UNITED STATES PATENT AND TRADEMARK OFFICE

APPLICATION NO.	FILING DATE	FIRST NAMED INVENTOR	ATTORNEY DOCKET NO.	CONFIRMATION NO.
10/707,050	11/18/2003	Randall A. Addington	1031011	1049

Office Action Summary

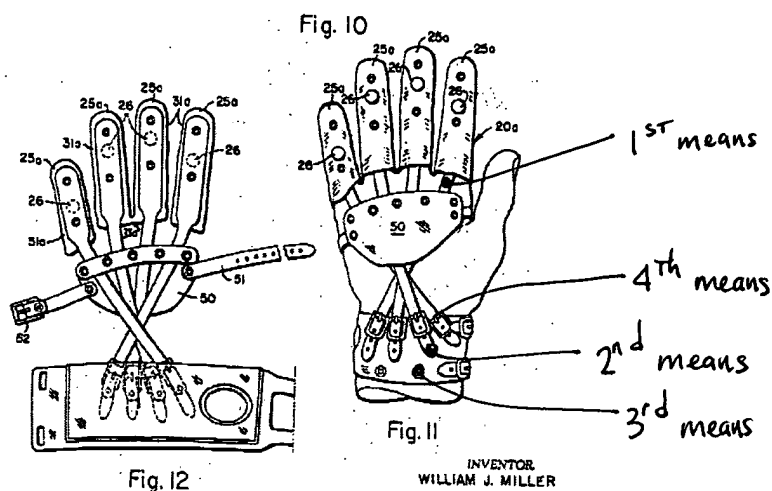
Miller discloses a bowler's glove 20 covering the bowler's middle finger and hand and proximate the bowler's wrist. The glove 20 includes an adjustable tensioning strap 52 to adjust the middle finger into a curved position and support straps (50; see figure below) placed across the tension strap 52. First means 52 for applying tension force to a bowler's finger for forcing the finger into an adjusted curved position, second means (see figure below) for applying a force against the

first means for retaining the first means substantially against the finger and wherein the second means includes a third means (see figure below) for supporting the force against the first means is provided. Note: Adjusting (or tightening) the strap of the middle finger with respect to the other straps will make the middle finger curve concavely.

With regard to claim 2, the third means includes fourth means (54; see figure above) for fastening the third means to the second means.

tensioning strap 52 to adjust the middle finger into a curved position and support straps (50; see figure above) placed across the tension strap to support a force against the tension strap 52 comprising a tension strap mounted in a bowler's glove between the fingers and wrist and at least one support strap attached to the glove and mounted in opposition to the tension strap.
